1431 NW 65th Street

MUP Recommendation Packet | Project #3030433-EG | June 03, 2019

① Street View looking Southeast

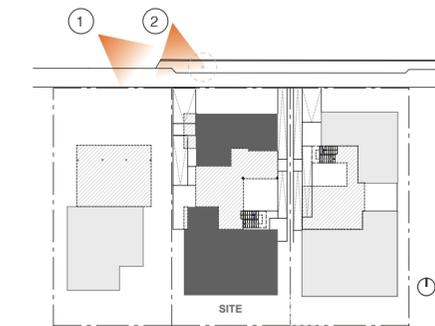
A particular feature the Board recognized was the recessed balconies on the 1800 John project (page 16 of the EDG packet), and they asked the applicant to explore that idea is part of the facade composition. (DC2-C, DC1-A, DC2-B)

- The facade composition is consistent with the sketch diagram presented at EDG. The north and south facades consist of large windows and doors as part of a dynamic and rhythmic pattern. Secondary architectural elements, such as balconies combined with material changes provide articulation to the design proposal.
- The east and west exterior facades act as more solid, anchoring walls that incorporate punched windows and material texture to reduce the overall scale of the proposal.
- The combination of dark tones, articulated windows, and decks on the north and south facades along with lighter tones on the east and west facades create visual interest and an articulated yet subtly modulated facade at the street.
- Privacy elevations show minimal exposure to and from adjacent structures.

Street View looking Southeast

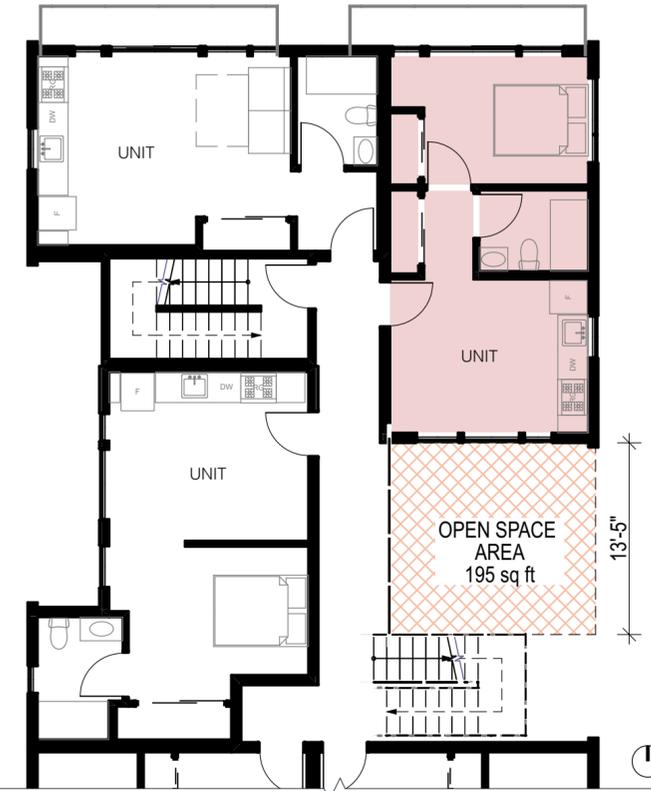
In response to the Board's guidance, an exploration of recessed balconies on the street facade was conducted to see how it could complement the design.

Infill high-quality Ceraclad material providing a visual and tonal break
 DC.4.A.1 - Exterior Finish Materials

Infill white panels and vertically-organized glazing accentuate the vertical nature of the building structure and complement the vertical lines of the building edges
 DC.2.D.2 - Texture

Generous deck projections span the width of the units, providing opportunities to engage with the street
 DC.2.C - Secondary Architectural Features

Extended deck projection to visually connect proposal to deck projection on neighboring structure to the east
 CS2.B - Adjacent Sites, Streets, and Open Spaces

① View of Open Courtyard from Entry Ramp looking Southeast

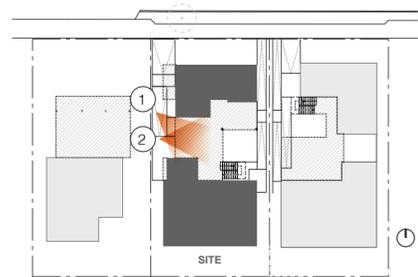
The Board expressed broad support for the idea of the courtyard, but had some questions about the character of the space and its relationship with the space to the south.

The Board asked to see detailed drawings of the space (plan, sections, elevations) including experiential perspective drawings from key vantage points.

- The courtyard is designed to be central to the project's circulation and program of spaces. In response to concerns from the Design Review Board Members, the main entry ramp connecting the sidewalk to the courtyard has been moved from the east to the west side of the site. This greatly reduces the visual impact of railings and ramps along the eastern property line which was a concern of the Board.

- The sequence of entering the site from NW 65th Street is also greatly improved, allowing residents to be fully protected from the weather and access the two stair cores, mailboxes, and the package storage room.

- As residents enter the courtyard from the entry ramp, they immediately have a visual connection through the site to the adjacent structure's courtyard. This visual connection is supported by the dynamic relationship between the proposed structure's courtyard and that of the adjacent structure's, generated predominantly by the exterior stairs, walkways, and dynamic elevated building masses.

1 Axonometric view showing massing relationship between proposed structure and neighboring structure to the east

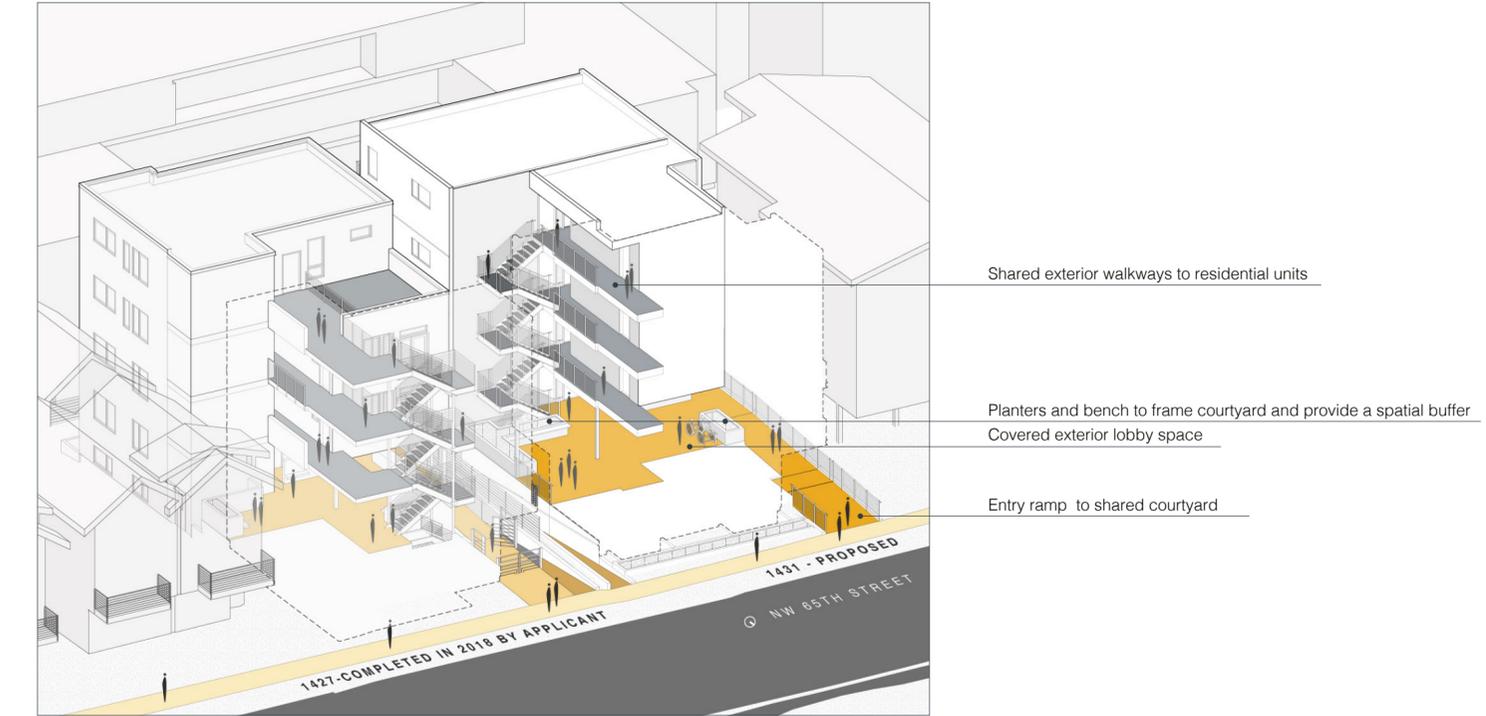
In conjunction with this, the Board asked that similar drawings explaining the relationship with the space to the east be included. (CS2-B-3, PL1-A-1, DC3-A, DC3-C, DC3-B, CS1-B)

In response to the Board's guidance, the design proposal is further developed in relationship to the neighboring structure to the east, also designed by the applicant, with particular attention paid to the visual and spatial connections between the courtyards.

1 View looking West

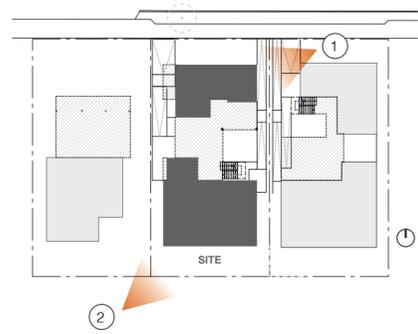
The Board appreciated the high-quality materials evident in the precedents in the EDG packet and encouraged the applicant to retain this approach. (DC4-A)

- This modern design uses durable materials in a manner consistent with the neighborhood. Material treatment as well as color distinction supports the design concept presented at EDG of a massing approach to the site that is carved away at its edges and interior by exterior circulation and shared gathering spaces.

- As suggested by the Design Review Board, the entry ramp and courtyard paving is proposed to match, in tone, the exterior siding at the walkways and the recessed exterior walls along the west facade, to emphasize the concept of an eroded central courtyard.

- Texture in the siding treatment is intended to add visual interest and clarity to the design concept.
- Material use follows the conceptual sketch diagram presented at EDG, with areas of large glazing on the north and south facades balanced by more solid east and west facades featuring selective punched openings.

- The east and west facades act as anchoring element to the design with a distinct material treatment from the north and south facades.
- The material and visual contrast in the proposed design elements create greater clarity in the design concept, adding visual interest and depth along the street facing facade and in the courtyard.

1 View of bicycle parking in the courtyard looking Northwest

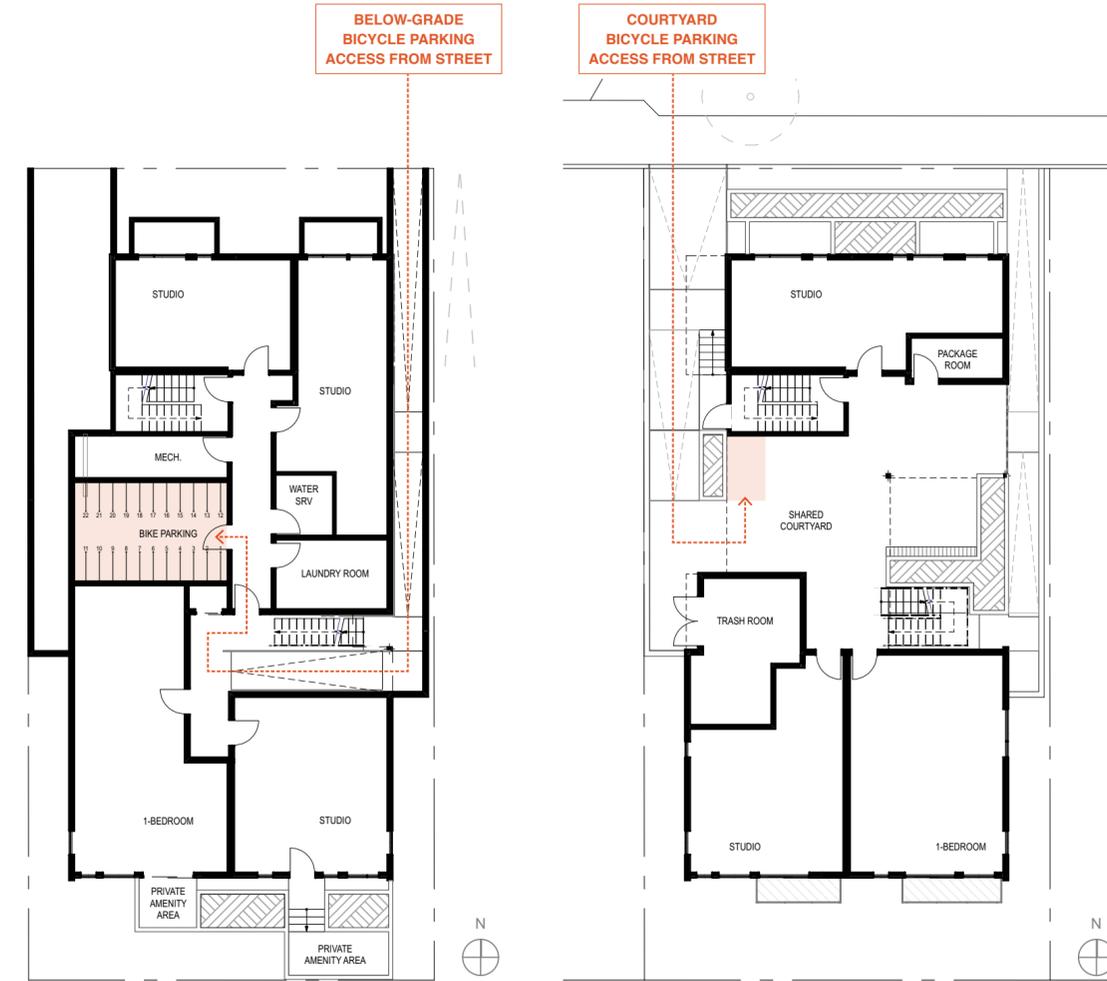
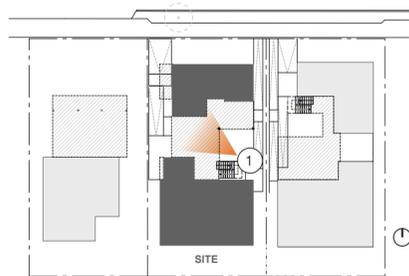
The Board would like to see how bikes come to the site and are stored and how the design of that sequence supports their use. (PL4.B)

- Bicycles will access the site through the exterior eastern ramp down to the basement and into a secured bicycle parking room.
- The sequence to the bike parking room is direct and without barriers. The design provides twenty-two bicycle parking spaces, equivalent to the number of residential units in the proposed structure.
